RESPONSE TO BIDDER QUESTIONS

Date: August 31, 2017

From: McAdams

Re: **Belk Plaza Revitalization
UNC Charlotte
CLT-1010**

Scot Division of Ardox Corp.
Catalog: Scot.60, Vers 10.2
Endsuct-Encl - 1800
Design Point: 1100 US gpm, 28 ft

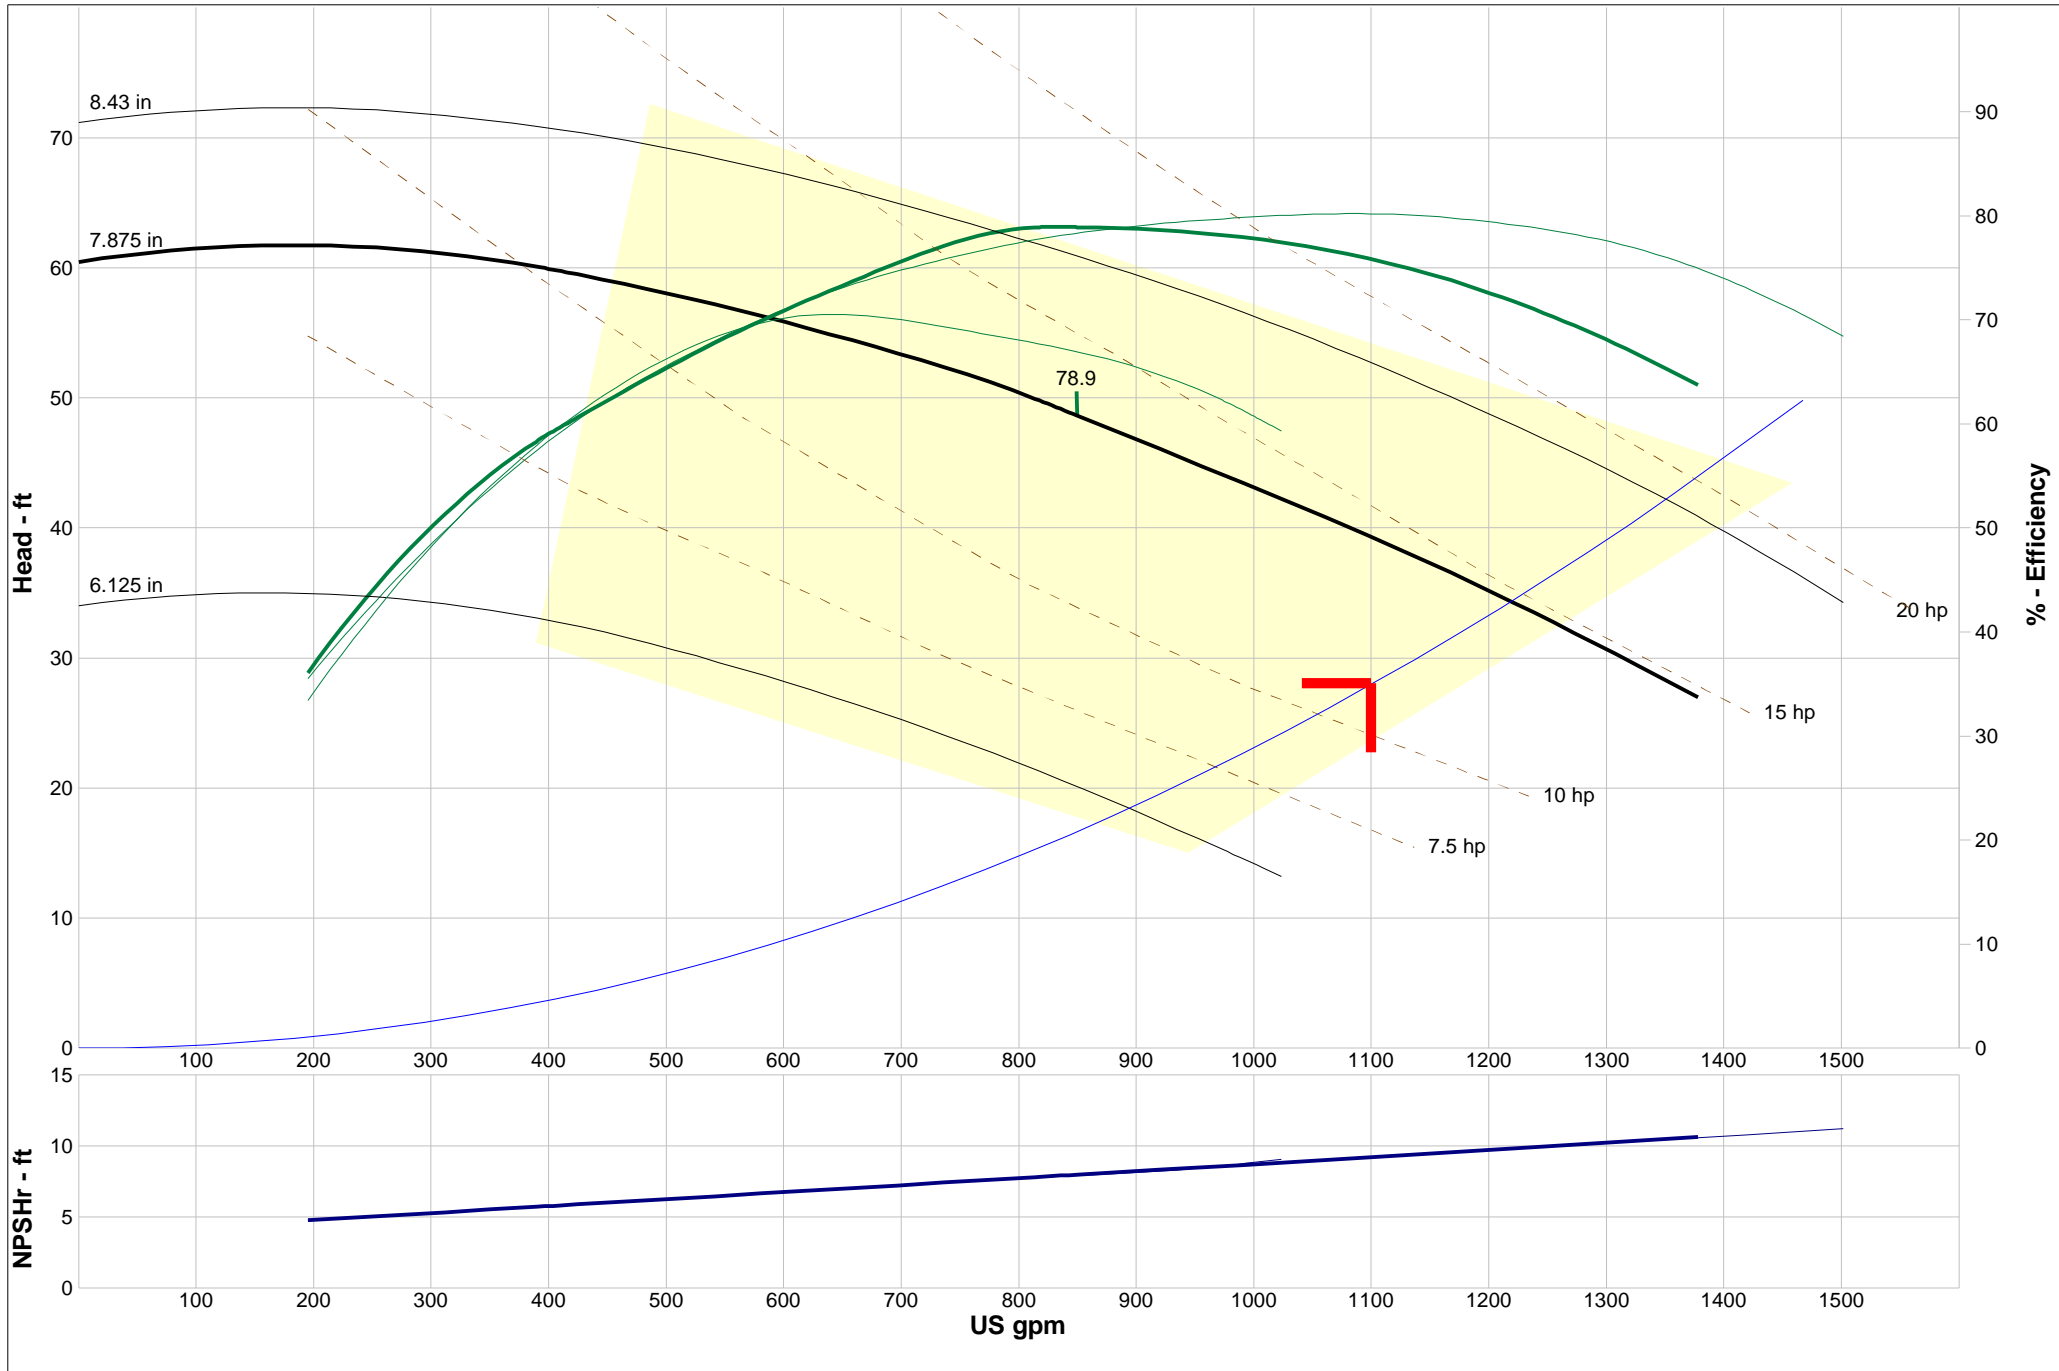
1. What is the GPM Flow and Head pressure of the 15 HP display pump?
1100 gpm at 28' TDH. See attached pump curve.
2. Are the 72 LED Lights all white or RGB's?
LED lights are all white.
